**TB 188**

#### SAFETY ISSUE - TEMPORARY WORK PLATFORM

For the Attention of:	Platform Lift Installers
	Platform Lift Trade Customers
	Technical Support Engineers
Date:	1 <sup>st</sup> November 2022
Product:	Stannah Midilift – All models
Subject:	Midilift temporary work platform

Temporary working platform assembly.

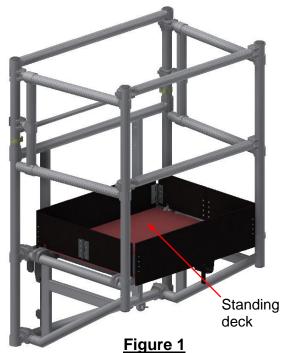
This Technical Bulletin has been distributed to emphasize the correct installation of the standing deck, on the working platform, used to install Midilift platform lift products (see Figure 1).

Figure 3
Spring-loaded security lock

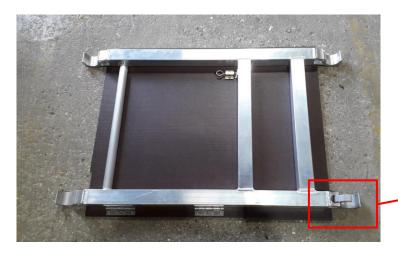
The standing deck has two crossmembers on the underside with a locating hook at each end (see Figure 2). It should be noted that one of these hooks, on the hinged side of the deck, is fitted with a spring-loaded security lock (see Figure 3). This is to prevent the deck from being accidently displaced. It is therefore important to ensure that this lock is fully engaged prior to accessing the working platform.

The security lock was introduced from 2017 onwards to comply with new safety guidelines. Any platforms manufactured prior to 2017 will not have the security lock fitted. For those platforms without the security lock it is recommended that the platform deck is suitably lashed into place, on the hinge side, to prevent accidental displacement.

If a security lock is fitted then ensure that it is fully engaged prior to accessing the working platform during installation.

If a security lock is not fitted then the platform must be suitably lashed in position prior to accessing the working platform during installation.
